# MARIA CREEK

## SUSTAINABLE INFRASTRUCTURE PROJECT

### Question and Answer (Q & A)

*These Q & A have been prepared to reflect key items identified through submissions to the Community Focus Group, as well as other Frequently Asked Questions from community members.*

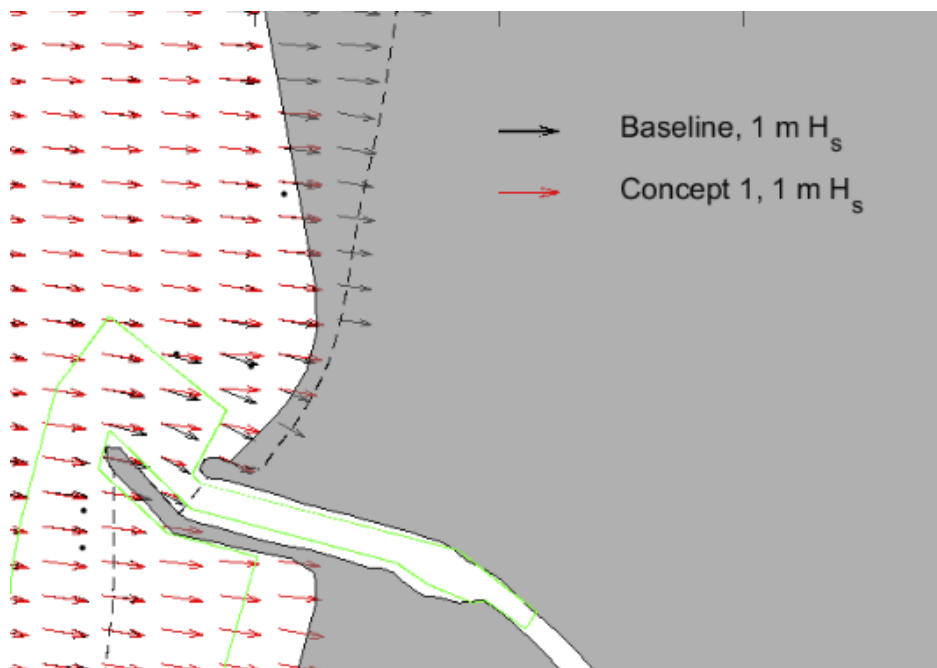
In addition to the 30,000m<sup>3</sup> – 50,000m<sup>3</sup> of sand management, approximately 30,000m<sup>3</sup> of seagrass wrack management is required each year. It is important that we understand the physical drivers of wrack accumulation, as this is key when considering the effectiveness of any reinstatement option.

The key driver of wrack accumulation within the channel is storm winds and waves which mobilise wrack into the creek channel. The general process is outlined below:

- Wrack is mobilised offshore by storm events, typically in Autumn and early Winter;
- Storm winds and waves keep wrack on surface and push it onshore;
- Existing entrance is exposed from westerly to northerly storm conditions;
- Wrack settles out within the sheltered creek where wave and wind energy decreases.

The modelling diagram above shows the effect of storm direct on wrack accumulation within the channel. Any concept option should aim to reduce storm wind and wave exposure where possible.

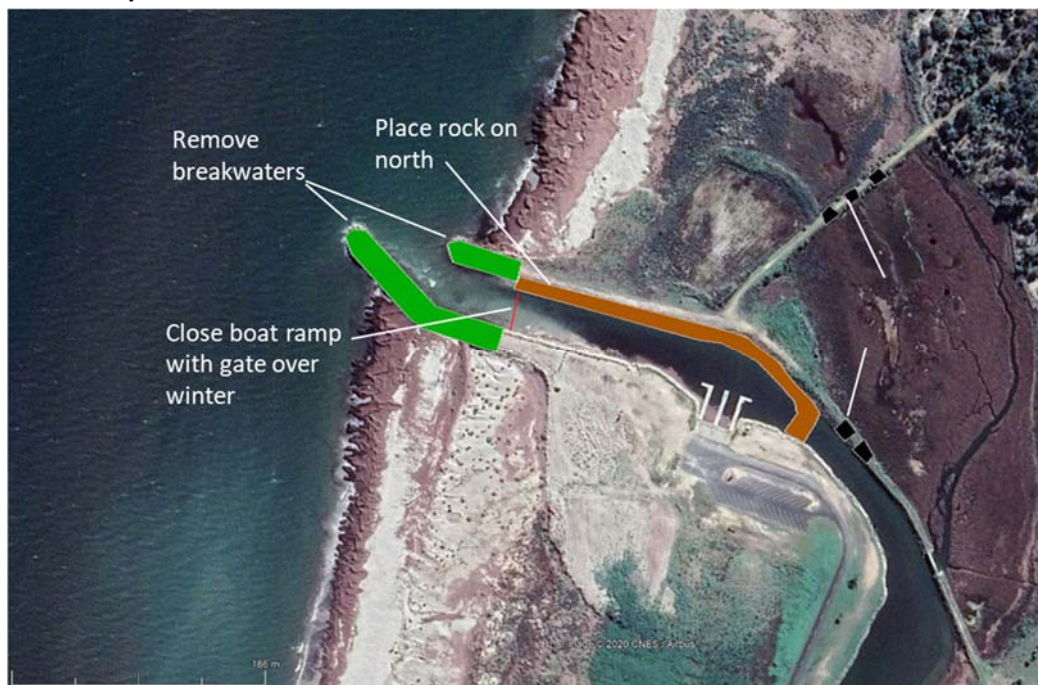
6. **Could you remove the groyne and replace it with a sea wall parallel to the shoreline, say 200m out (similar to Port MacDonnell)? Correctly positioned, it would provide protection and allow sand and weed migration to happen unimpeded from South to North. A parallel wall provides the ultimate protection for boaties. I don't think Wavelength raised this option. (PF)**

It appears that the Port MacDonnell location has a connected breakwater with an orientation that extends from the shoreline to be parallel to the shoreline (as seen below). The photo also shows that the breakwater is not saturated on the western side, so it will continue to trap sand and prevent it from entering the harbour from the west. A detached or offshore breakwater would allow sand to move directly into the harbour from the west, impacting navigation.

The photo shows the breakwaters protects the area from the SW wave action, however, Port MacDonnell has a very different site orientation in comparison to Kingston. We have also found that the area around Port MacDonnell, such as Carpenters Rocks, has lower sediment availability and thus transport than Kingston and has nearshore reefs and natural headlands that the breakwater is tied into.

In the case of the Maria Creek, the removal of the existing breakwaters and replacement with an offshore breakwater would result in the loss of Maria Creek as a usable boat launching facility. The sand saturation level of the southern beach would remain at 100%, resulting in nearshore sediment transport accumulating within the Maria Creek channel in the protected wave shadow created by the offshore breakwater. This would encourage sand to settle out in the calmer waters behind the breakwater (in the entrance channel), leading to siltation within the channel and an unnavigable entrance.

Offshore breakwaters can be used successfully as an adaptation strategy (erosion protection) in some locations, however, is not a viable option for the challenges faced at Maria Creek.

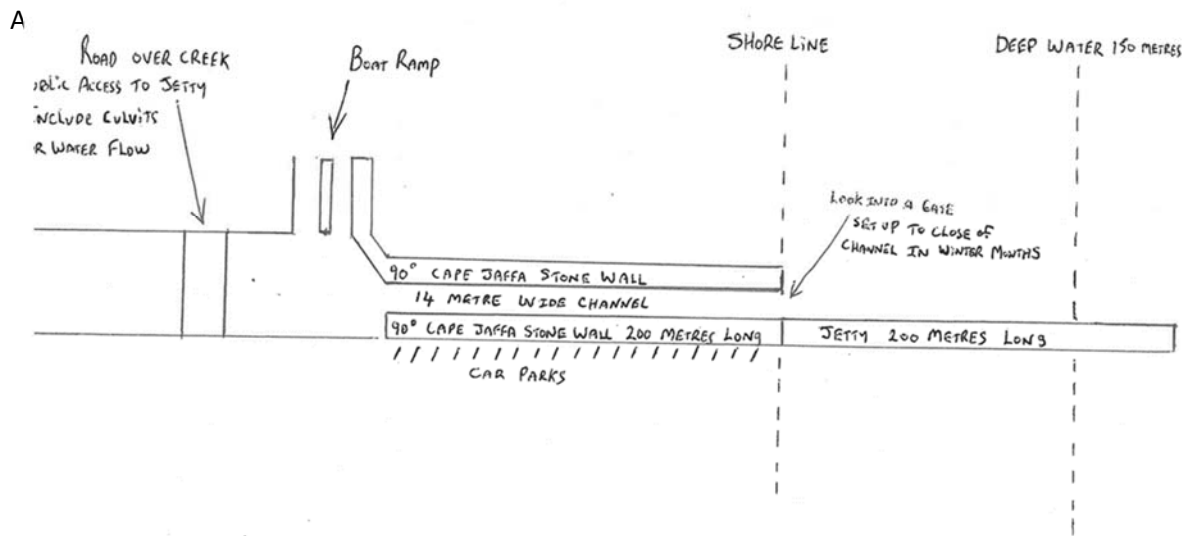
7. A community submission proposed to divert the creek flows and widen the creek channel (EL). A first pass assessment was provided at the Community Focus Group meeting and an overview of the assessment is provided:

The proposed option was discussed at length in the Community Focus Group Meeting 4 held on 26 October 2020. There were a number of challenges identified in this proposal, which broadly included:

- Capital cost to remove breakwaters, cartage and placement on north ~\$3.2M (doesn't include costs for culverts, ongoing maintenance, gates etc);
- Southern breakwater still at full saturation (i.e. doesn't treat the main cause of sand build up);
- Increased sand management costs (reactive management as no buffer on southern side):
  - Dredging of entrance in October
  - Maintain dredging full time from October to May to remain navigable
- Increased wrack from more exposed entrance;
- Requires management of two entrances (responsibility to ensure creek flows are maintained even if diverted);
- Potential environmental impacts of closing basin over winter due to low flushing rates;
- Significant impact on creek flows and flooding from culverts.

Given these challenges, this proposal was not recommended to be pursued further in the presentation by Wavelength. The community submission and this concept was put to the Community Focus Group who advised it had been adequately assessed and they did not require any further investigation into this particular concept.

Proposal from Scott Gluyas and Don Richards for Discussion

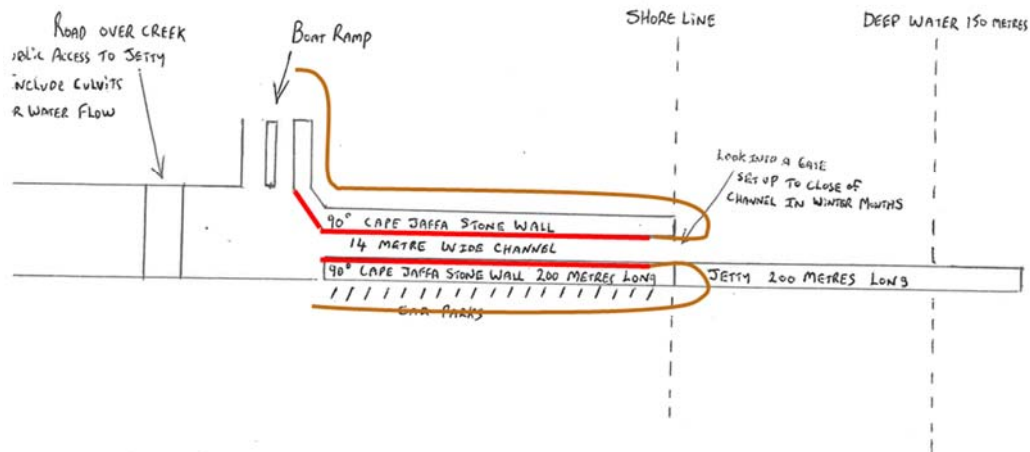
8. A community submission proposed a significant infrastructure change including stone walls and jetty to allow for excavator access (SG/DR). A first pass assessment was provided at the Community Focus Group meeting and an overview of the assessment is provided:

The proposed option was discussed at length in the Community Focus Group Meeting 4 held on 26 October 2020. The proposal put forward involved significant new infrastructure, which incorporates the following components:

- improved access for long-reach excavators to remove sand and wrack;
- new jetty, with excavator access;
- vertical walls along entrance for reach across channel from north to south;
- improved public access to northern breakwater via bridge across channel;
- narrower entrance channel to increase currents on outgoing tides.

However, upon first pass assessment, the proposal requires further infrastructure considerations including the following:

- Rock breakwaters are still required on the ocean side of the vertical walls (see brown lines in image below), as vertical walls would be unable to withstand loadings or wave energy as standalone vertical walls;
- Significant load rating required on all proposed structures to withstand access by 30-40t long-reach excavators as proposed. Sheet pile walls likely to be required within the creek (see red lines below).

The proposal also provides a number of challenges, which were broadly considered in the presentation to the Community Focus Group and include:

- Significant capital cost;
- Increased wrack and sand volumes, as more exposed to west due to partial removal of existing southern breakwater;
- Southern breakwater remains saturated (i.e. doesn't treat the main cause of sand build up);
- Reactive sand management required for daily removal of sand with a long-reach excavator;
- Accessibility and sediment spoil area on northern side;
- Similar on-going costs to Concept 2 but nearly twice 25-yr NPV cost;
- Aboriginal heritage impacts of car-park to north.

Given these challenges and particularly the significant capital costs, this proposal was not recommended to be pursued further. As discussed at length in previous questions, this proposal is focussed on increased accessibility (therefore reactive management), with the southern side still saturated, allowing the full 30,000 – 50,000m<sup>3</sup> of sediment to move into the entrance channel.

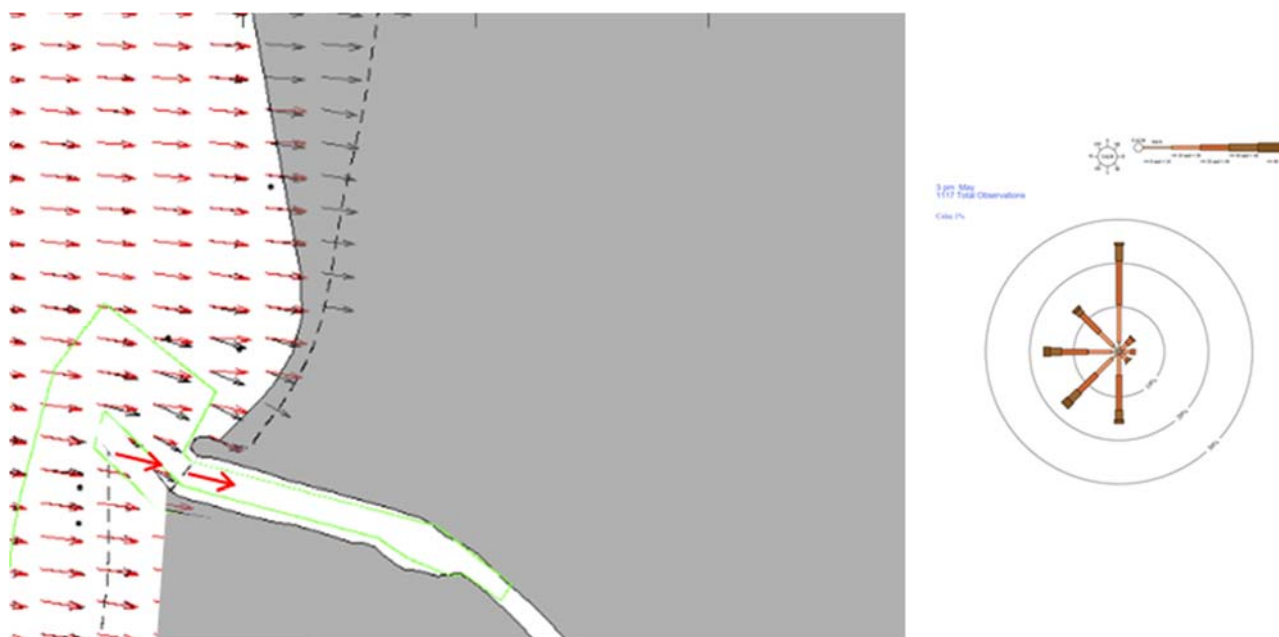
#### **11. Can we partially remove the breakwater for the sand to mobilise naturally and get some of the jetty back, and then reassess in a few years? There might be an opportunity once the breakwater is removed to just dig out the entrance? (JP / GH / TH)**

There are a number of considerations and challenges when considering the partial removal. A full model and technical note of the concept to understand the affects and impacts would be required, however, a high level first pass overview and key points are provided below:

- Partial (or full) removal of breakwaters would accept loss of the facility;
- The southern breakwater would still be at full saturation, resulting in the same challenges as present, just at a different shoreline position;

- 80m partial removal of breakwater would likely result in approximately 50m sand reduction at the jetty within 12-24 months following removal;
- Without the following sand management, partial removal would not result in a renewed opportunity to use the ramp:

- Capital dredging campaign to create buffer on southern side;
  - Ongoing sand bypassing of 30,000m<sup>3</sup> to 50,000m<sup>3</sup> per year;
- Increased wrack volumes and costs due to westerly storm exposure (existing breakwater provides some protection to these events currently);

The diagram below provides an indication of the likely exposure to waves and westerly storm exposure if the southern breakwater were to be partially removed:
